Groundwater Transfer Review Summary Form

Transfer/PA # T- 14697

Application: T-14697

1. Basic description of the changes proposed in this transfer: Add APOA for Certificate 98329. Will be used as their main well since it has more efficient power available for pump.

Figure 1: Map of T-14697

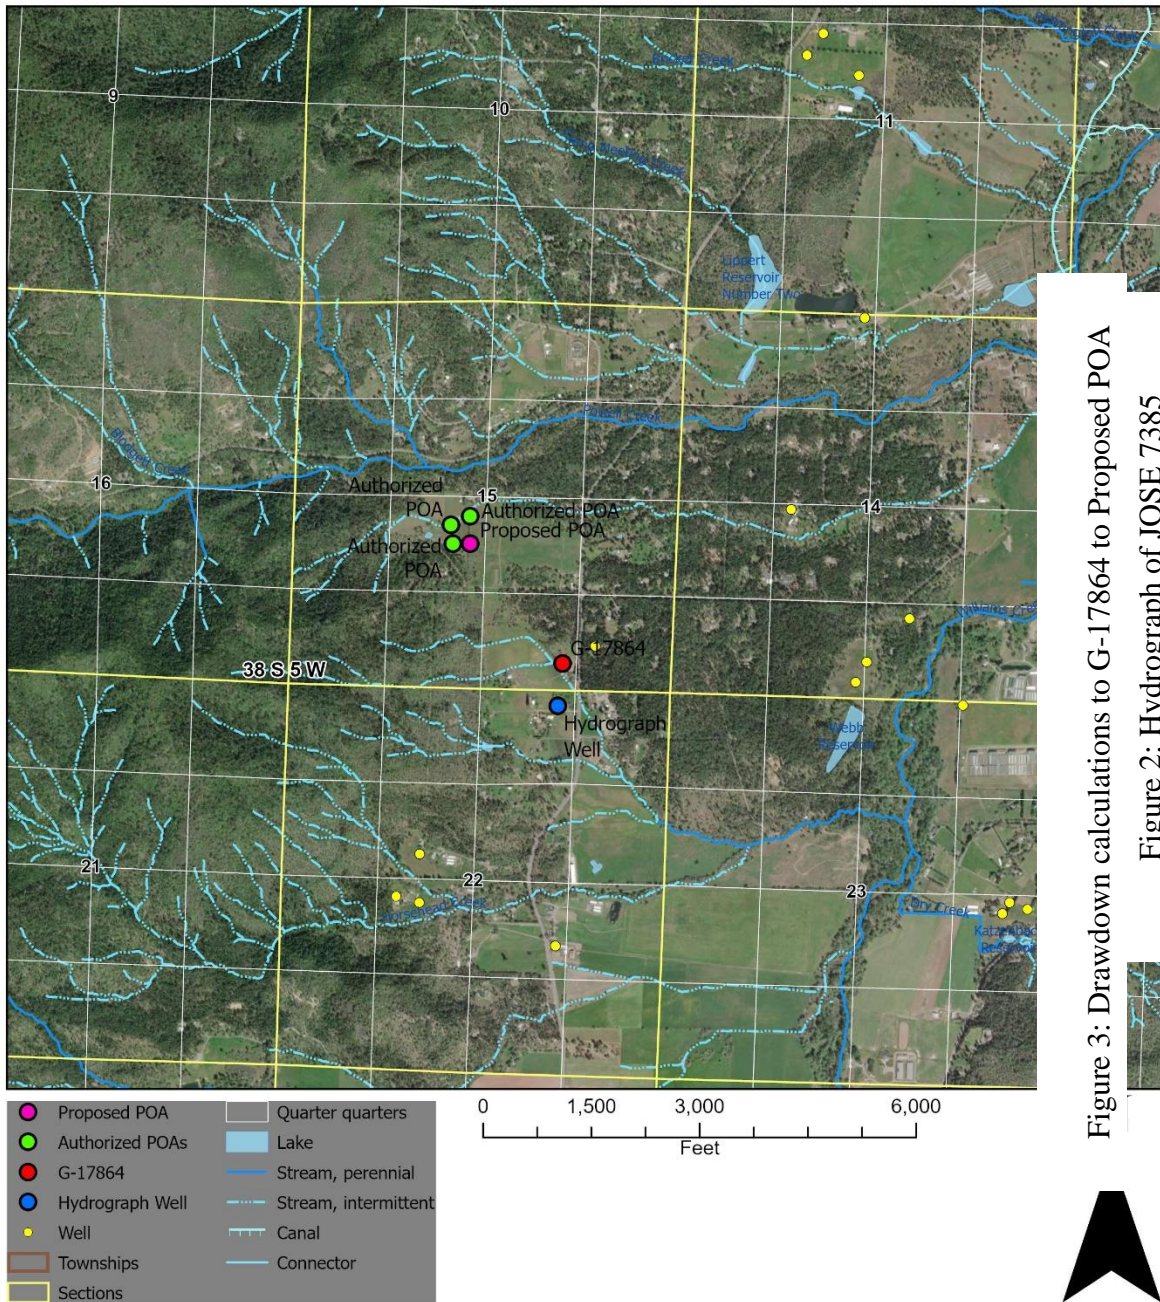
5. a) Will this proposed change, at its maximum allowed rate of use, likely result in an increase in interference with **another ground water right**?
☒ Yes ☐ No Comments: Closest well to proposed POA is JOSE 10480 (G-17864), which is 2100 ft away. Authorized POAs are 2250 – 2470 ft away from JOSE 10480. Based on distance to the nearest POA, this proposed change has the potential to increase interference with wells to the south and east.

6. a) Will this proposed change, at its maximum allowed rate of use, likely result in an increase in interference with **another surface water source**?
☒ Yes ☐ No Comments: Proposed APOA is moving use 140 ft closer to Horsehead creek (4650 ft away), 150 ft closer to Williams Creek (6340 ft away), and 190 ft closer to Webb Reservoir (5730 ft away). Proposed APOA is moving further away from Powell Creek.

Considering the inverse relationship of streamflow depletion and distance from well to stream (Barlow and Leake, 2012), there may be increased interference with Horsehead Creek, Williams Creek, and Webb Reservoir.
